System Sanitary Survey Report

SUBJECT: Richmond City
Waterworks: Richmond, City Of
PWSID: VA4760100

Survey Date: February 23, 2026

Figure 9. Raw pump motor screen (2025 left), Screen intact, all raw water pumps checked (2026 two photos on right)

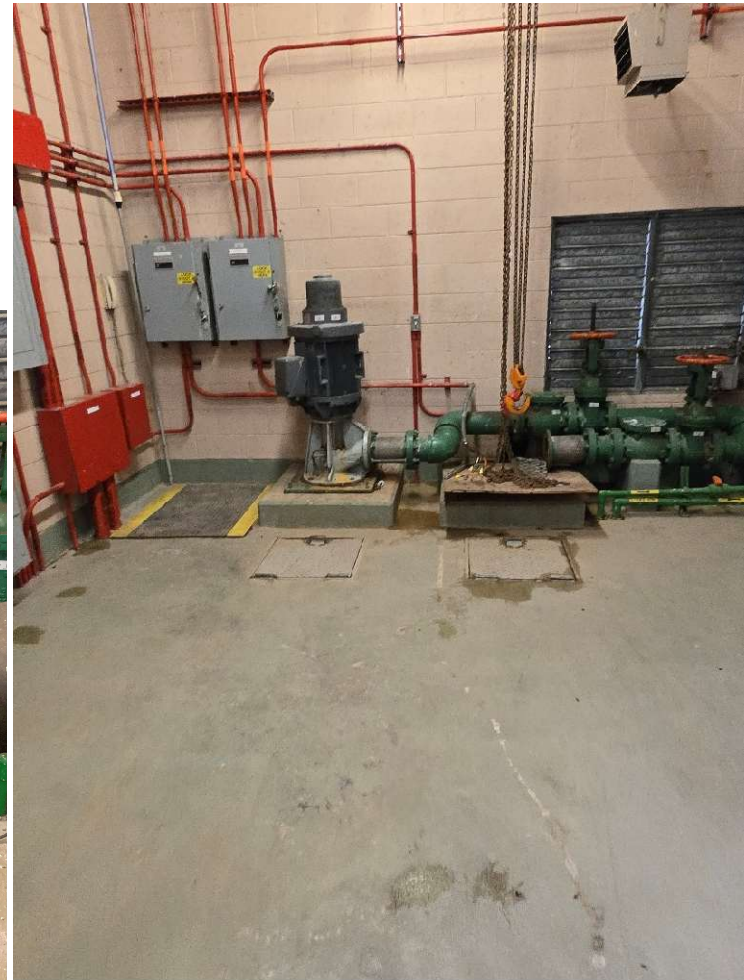
- Raw water pump shaft safety guards all in place and intact (Figure 9)
- No bird droppings or trash observed in raw water pump buildings, all buildings clean and orderly (Figure 10)
- All pumps operable
- Permanganate being fed year round downstream of raw water pumps (Figure 11)

Figure 14. Chemical totes near sedimentation basins (2025), No totes observed (2026)

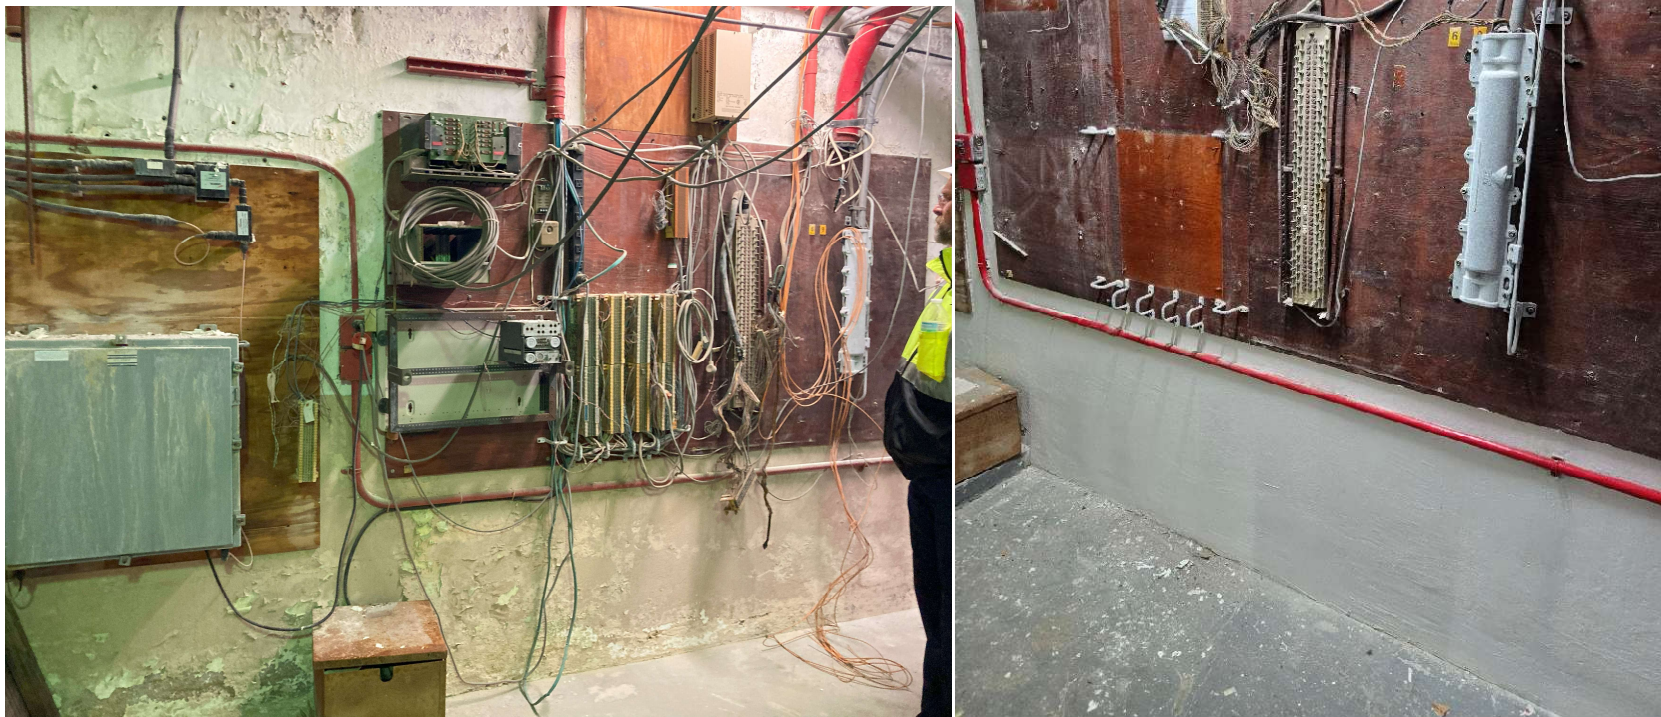
- No chemical totes observed near flocculators (Figure 14)
- Turbidimeters for settled water moved closer to sample point, shortens travel time to analyzer to provide more accurate readings

Figure 15. Obsolete equipment abandoned in place (2025), Wiring removed as much as possible (2026)

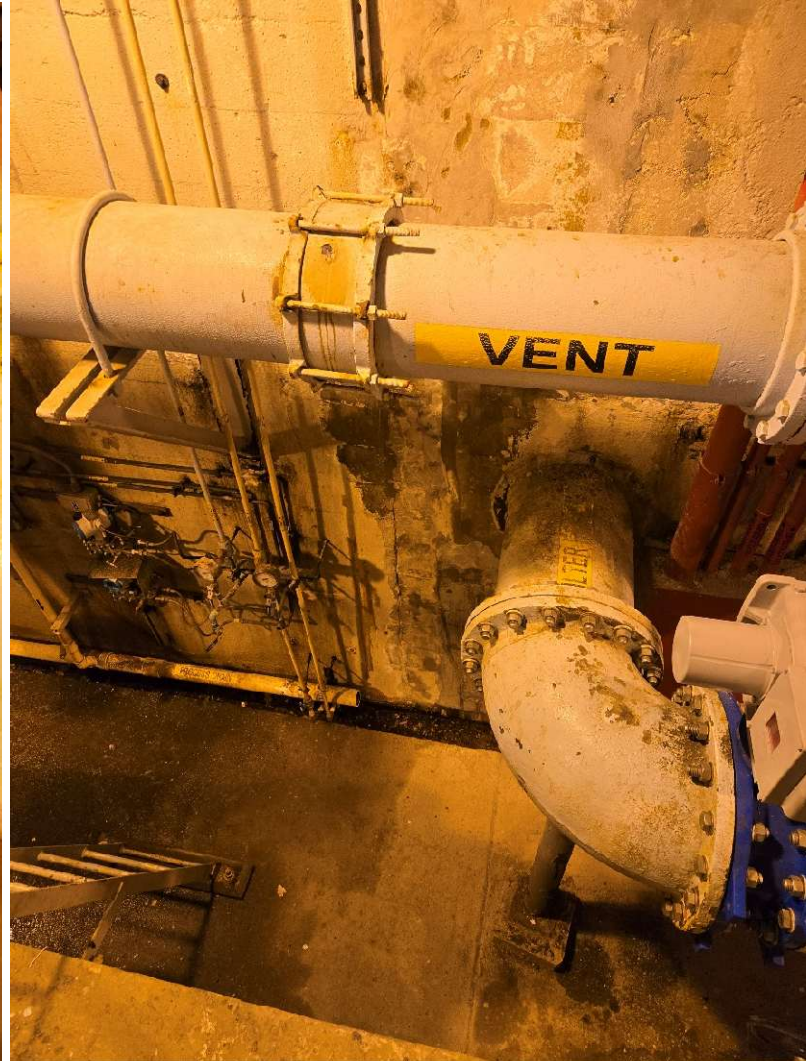
- System has resumed filter drop tests, backwash expansion tests. Plans to incorporate routine filter rise tests in 2026.
- Some of the obsolete electrical wires and associated equipment that were previously observed in the filter gallery have been removed as much as feasible and cleaned up (Figure 15)

Figure 16. Filter 6 leaking through wall (2025); No leak observed (2026)

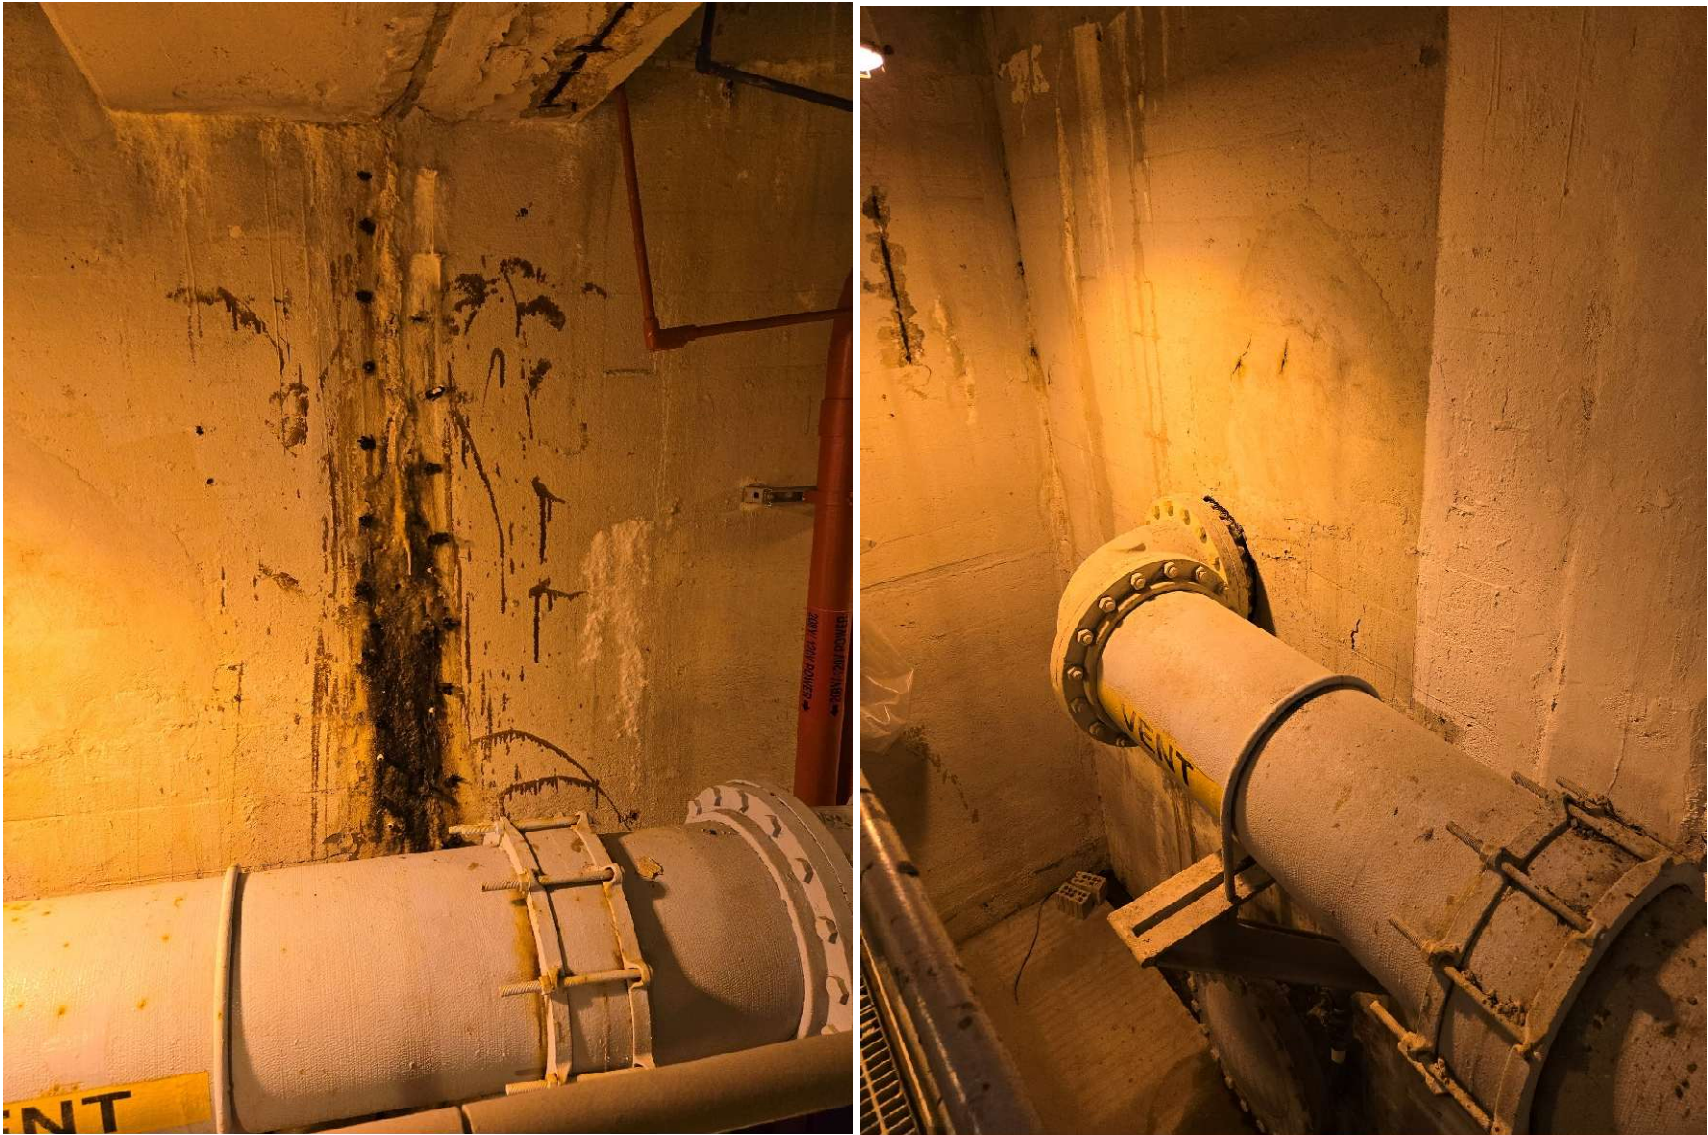
- No active leaks or biological growth observed (Figure 16, Figure 17)
- Backwash waste area appeared to have less standing water (Figure 19)

Figure 19. Backwash waste area (2025); (2026)

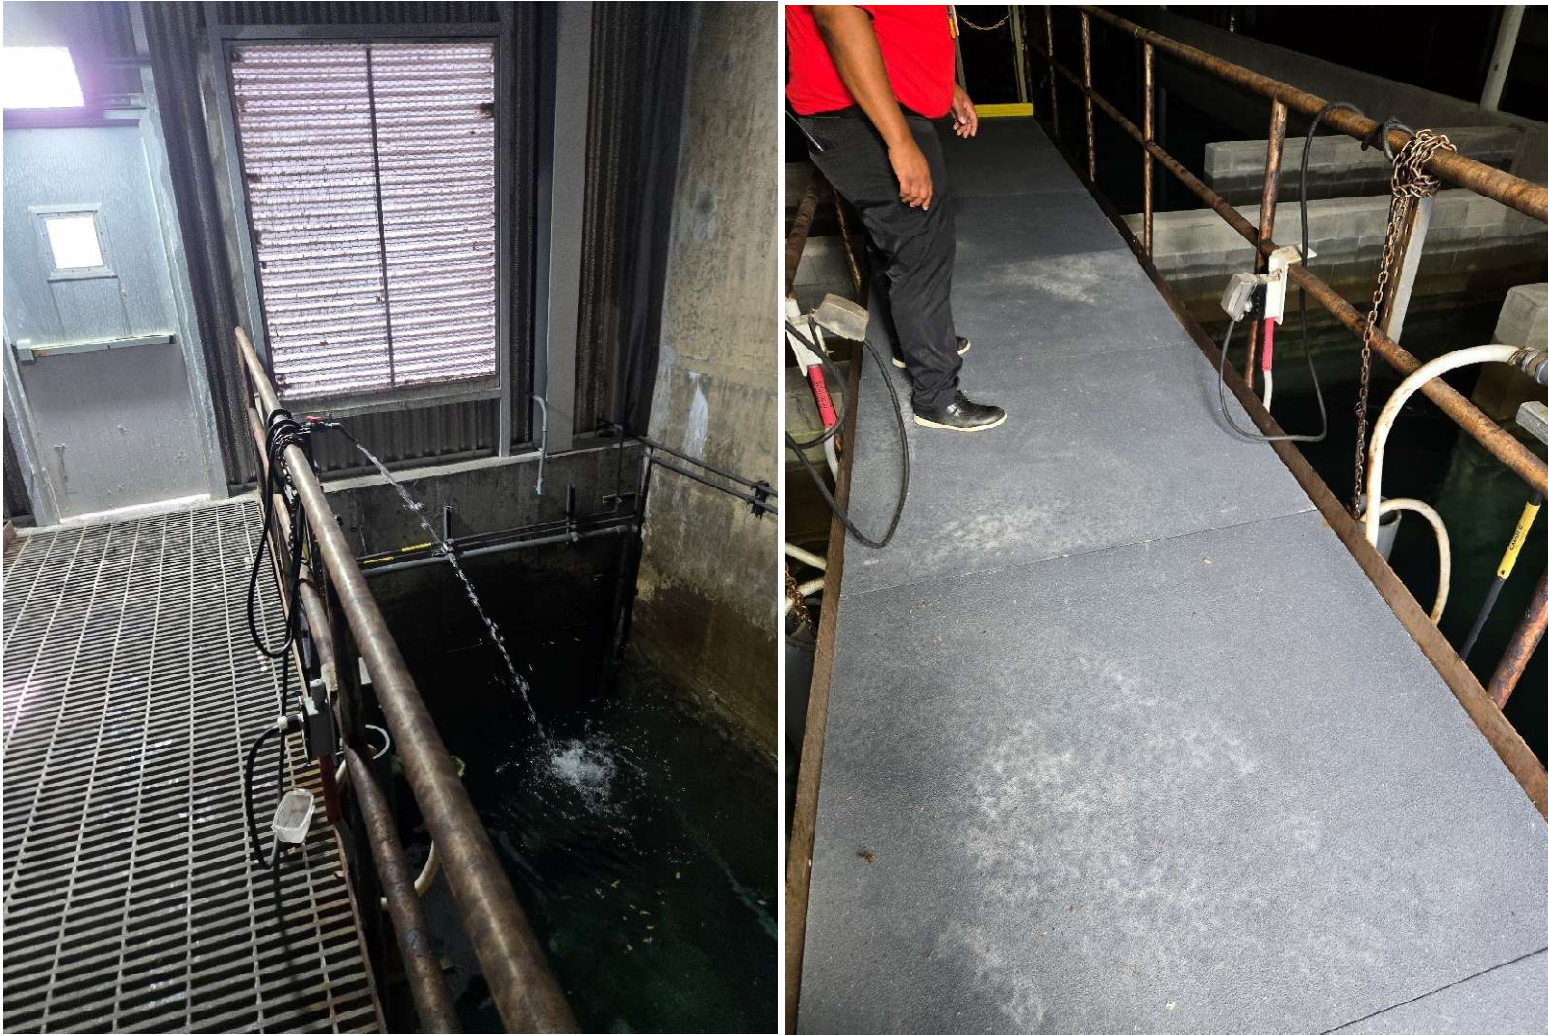
VDH-03	Plant 1 Filters	There appeared to be an active leak in the pipe gallery that appeared to have either biological growth or just appeared slimy. The leak should be investigated.	Concrete repair completed, no active leak or biological growth observed	Resolved	Figure 17
VDH-04	Backwash Waste Pumps	One pump was out of service and removed from its pedestal. A significant leak was observed coming from the isolation valve body (with a mat appearing to divert water away from an electrical box) and through the temporary cover plate. The check valve needs to be investigated, as do the gate valve and cover plate. Failure of the cover plate could result in flooding in the backwash waste pump area and pipe gallery.	Backwash Waste Pumps all installed (no leaks observed December 2025), Pump No. 2 needs to be investigated and repaired as needed (February 2026). Update: Check valve was replaced March 2026	Resolved	Figure 19

Figure 20. Water beneath grates visible, no solid base on walkway (2025); Grates covered (2026)

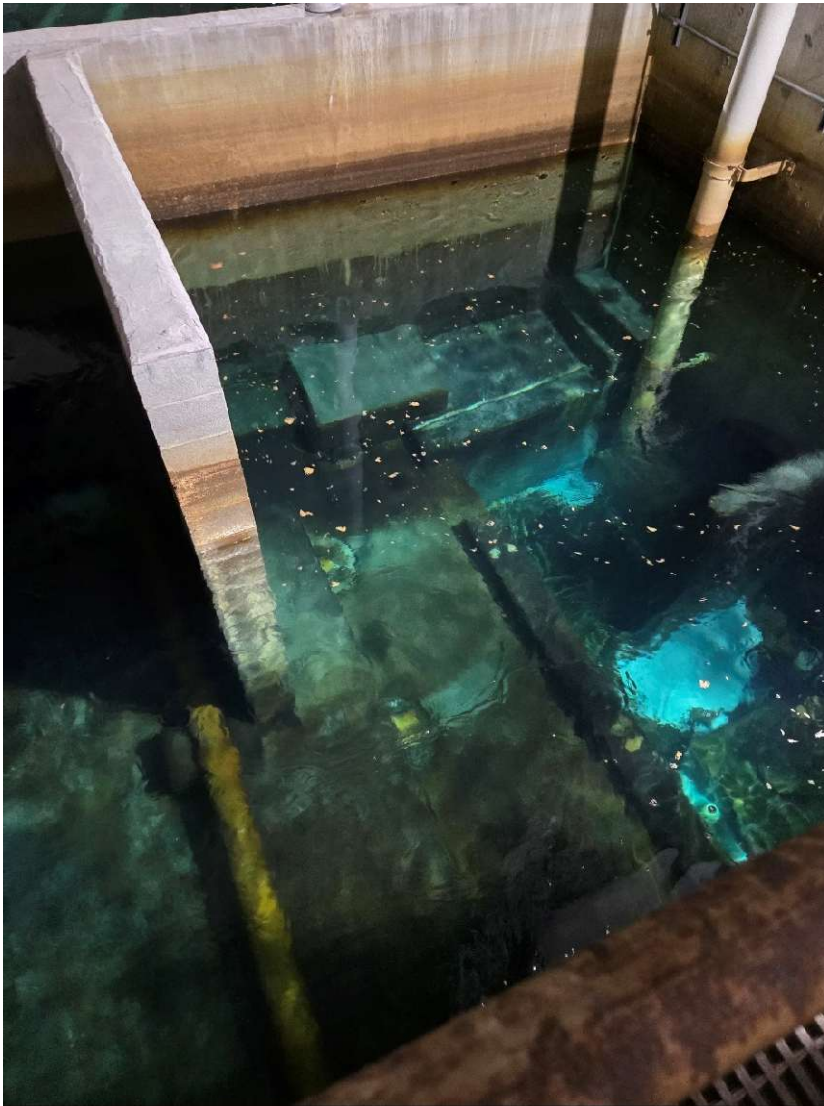
- All walkways into finish water basins have curbing, solid walkways to prevent dirt from falling into water (Figure 20)
- Walkways appeared clean with no debris observed (Figure 20)
- No scum observed at end of basins (Figure 21)
- System instituted routine cleaning of basins
- Previously observed obsolete PVC lines have been removed (Figure 22)
- Finish water basin lighting appears to have improved, brighter inside basins

Figure 27. Sanitary waste storage tank with concrete containment curbing

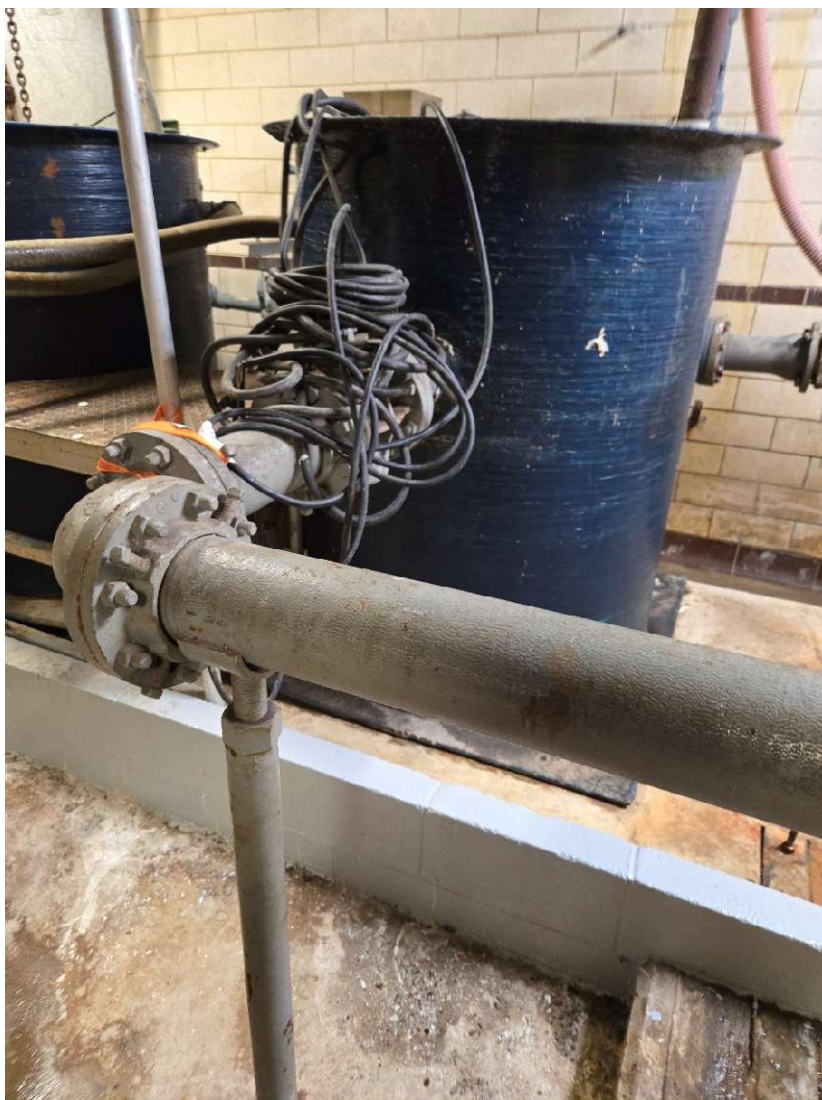
- Current sanitary holding tank and pump system provided with containment and planned to be replaced to pump sanitary waste directly without holding tank (Figure 27)
- System reports recycle flows on MORs using flows at waste lagoon, typically below 10% of total treated water flow. Recycle flow discharges at head of presedimentation basin, a lot of detention time prior to entering WTP raw water pumps. Direct measurement of recycle flow not done at discharge site due to water discharging through a sluice that connects waste lagoon and presedimentation basin
- Waste lagoon dredging project to start in March
- Waste pump No. 2 check valve appeared to need repair, pump observed spinning backwards momentarily. **Recommend investigation and repair of check valve at Waste Pump No. 2**

Figure 30. Corrosion at several pumps (2025), Pumps painted and no visible corrosion (2026)

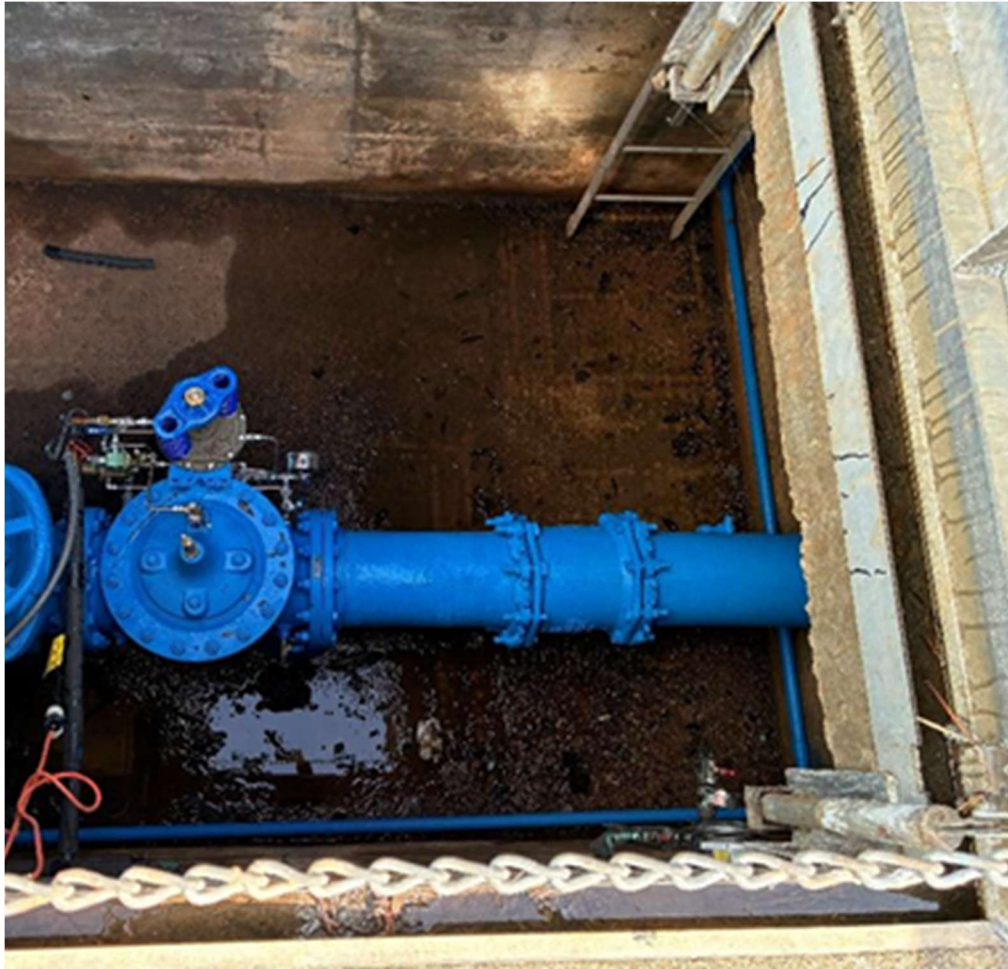
- Distribution system pumps appeared to be painted and no major signs of corrosion (Figure 30)
- Housekeep in distribution system appears to be improved, no signs of trash

VDH-09	Distribution System Tanks	Several tanks equipped with overflows that were piped to stormwater drains and sanitary sewer with no knowledge of backflow prevention provided. COR should investigate connection and determine degree of hazard and provide appropriate protection.	System investigated and provided adequate protection as needed	Resolved	None
VDH-10	Multiple Locations	There are various pumps, valves, piping, and other equipment that appear to have severe corrosion that may result in failure of the critical infrastructure. COR should conduct a condition assessment of all their assets in both the WTP and distribution system and identify what assets need repair, rehabilitation, or replacement.	Pumps, valves, and other equipment appeared to be repainted with no corrosion observed where painted. Waste pumps appeared to have some corrosion but are scheduled to be replaced with new equipment	Resolved	Figure 30
